LAKE HAVASU CITY, ARIZONA
ADMINISTRATIVE SERVICES DEPARTMENT
◆ PROCUREMENT ◆

**INVITATION TO BID
ISLAND WWTP FILTE UPGRADE PROJECT
PROJECT NO. B26-PW-107026-500701
ADDENDUM NO. 1
OCTOBER 2, 2025**

Date:	10/1/2025
Date:	10/1/2025
Date:	10/1/2025
Sheet	E-01

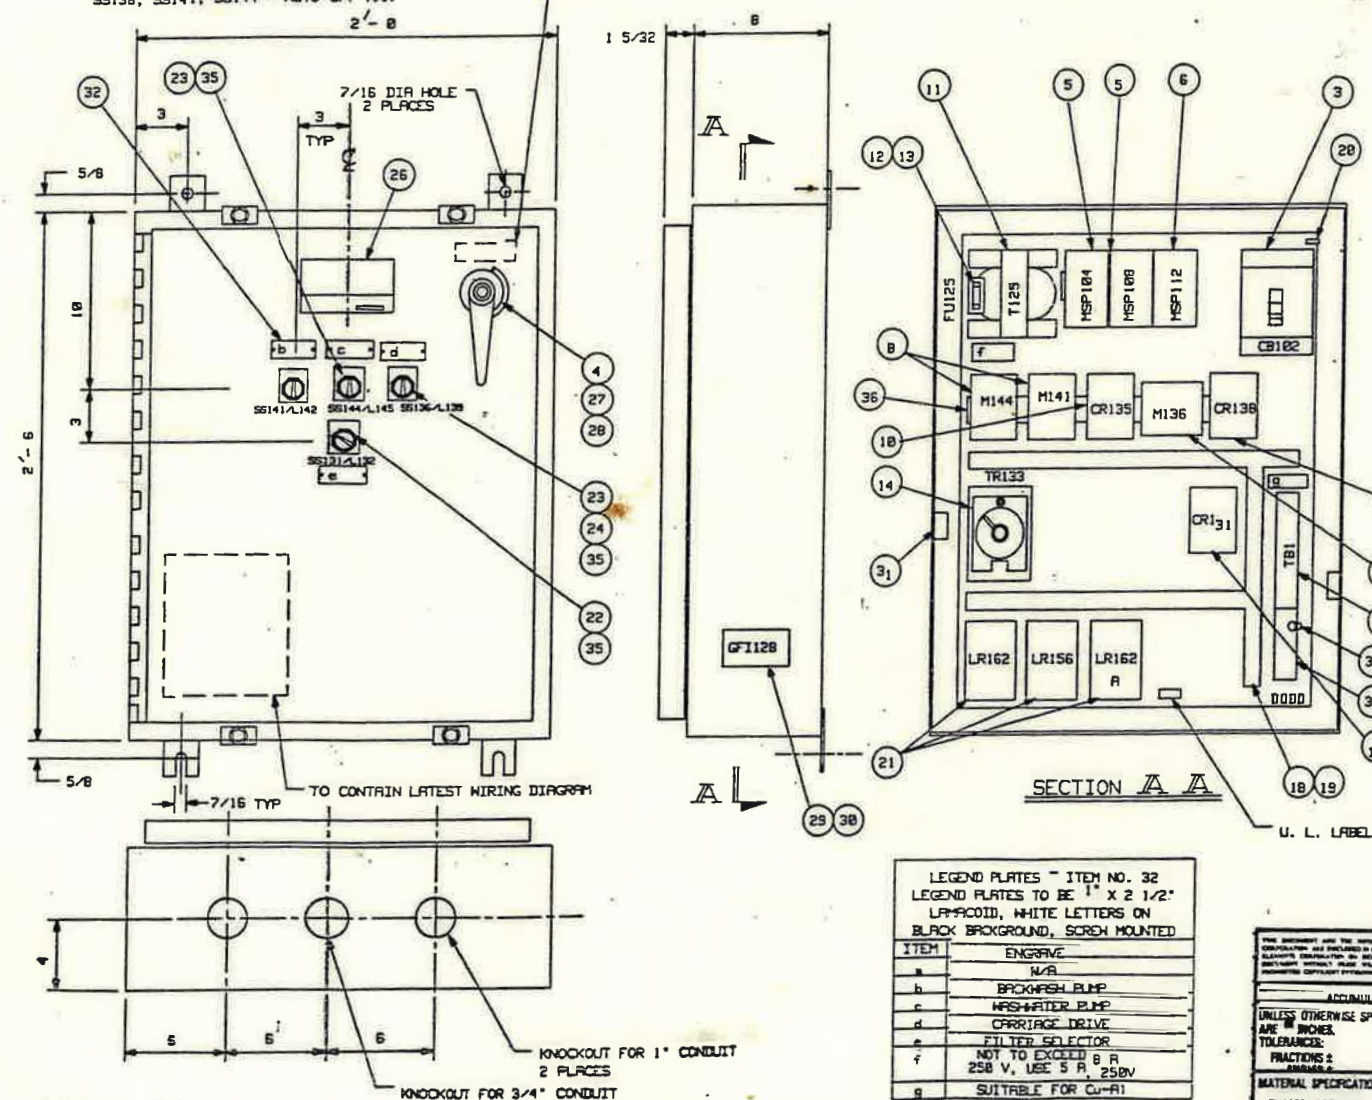
Question 3: Sheet M-03 indicates 2 filter Control Panels being replaced. Electrical One-line indicates 1 filter Control Panel. Which is correct?

Answer 3: There is one control panel per filter. The electrical one-line has been updated accordingly to show two control panels (See Exhibit A). The control panels will be identical.

DRAWING NO. 450337 - D35
 SHEET 1 OF 1

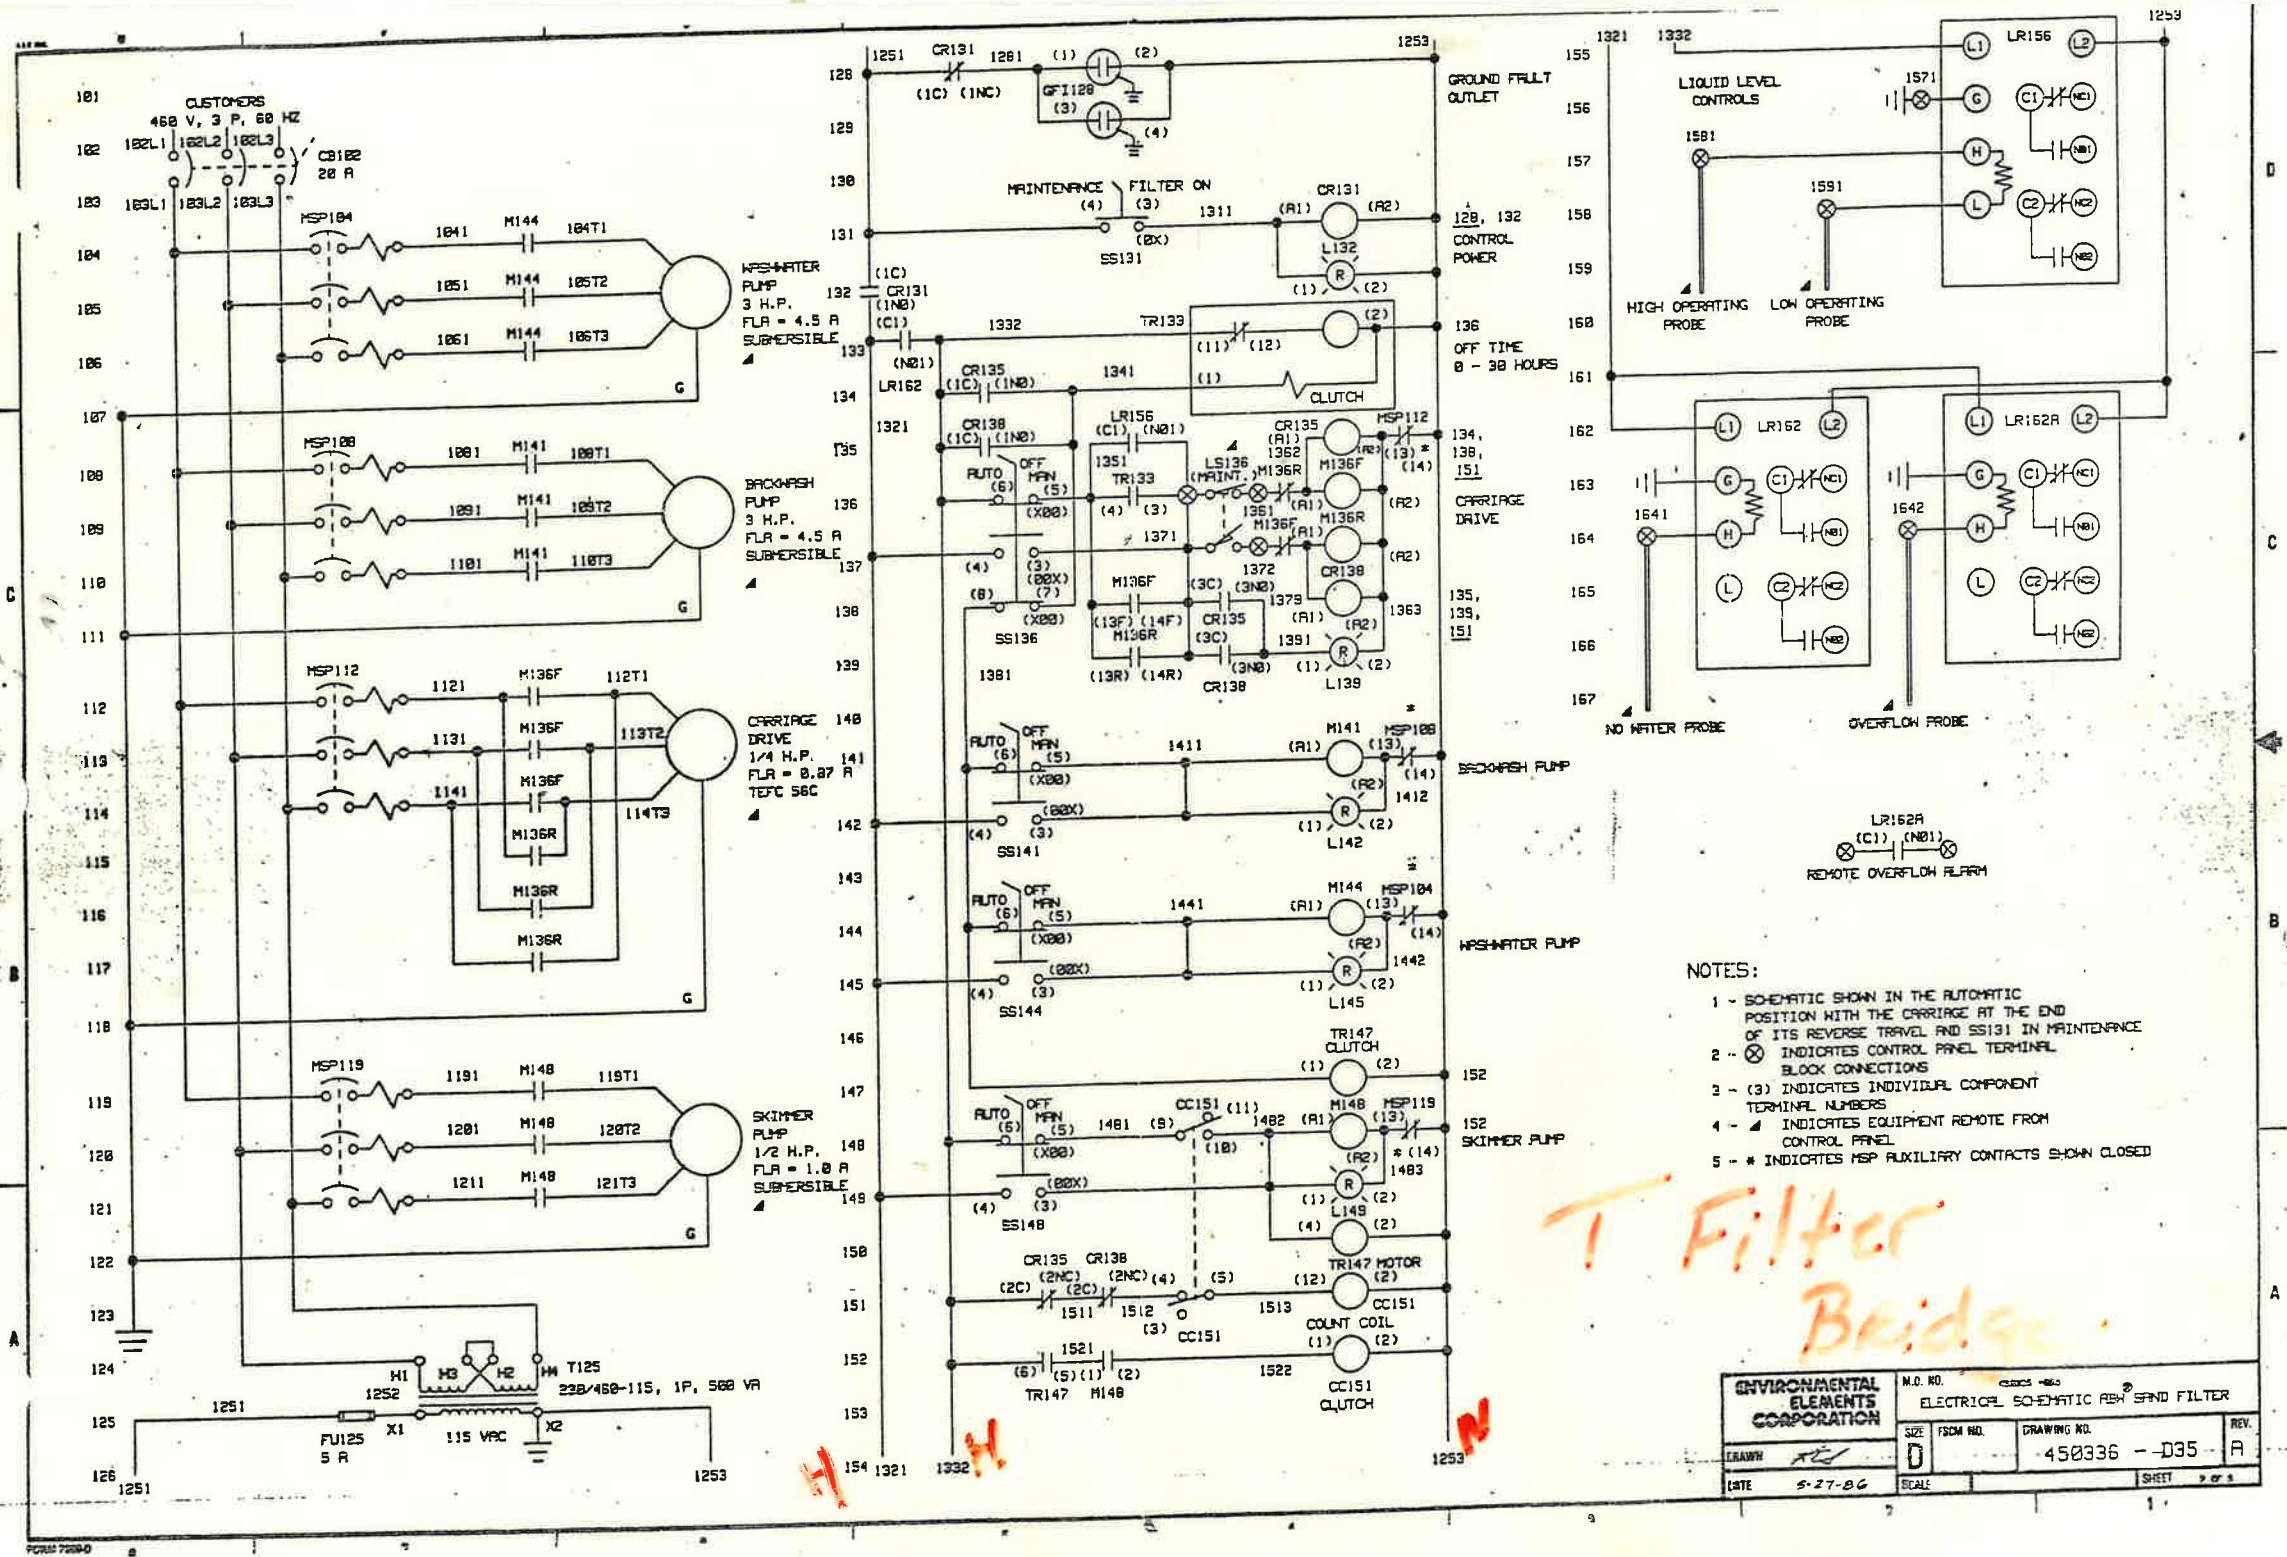
Question 19: Are the design drawings from the filter vendor available?

Answer 19: We only have the original design drawing of the control panel and electrical schematic for the filter control panel (See Exhibit C). There are two filter control panels that will be replaced, one for each filter, and they should be identical.
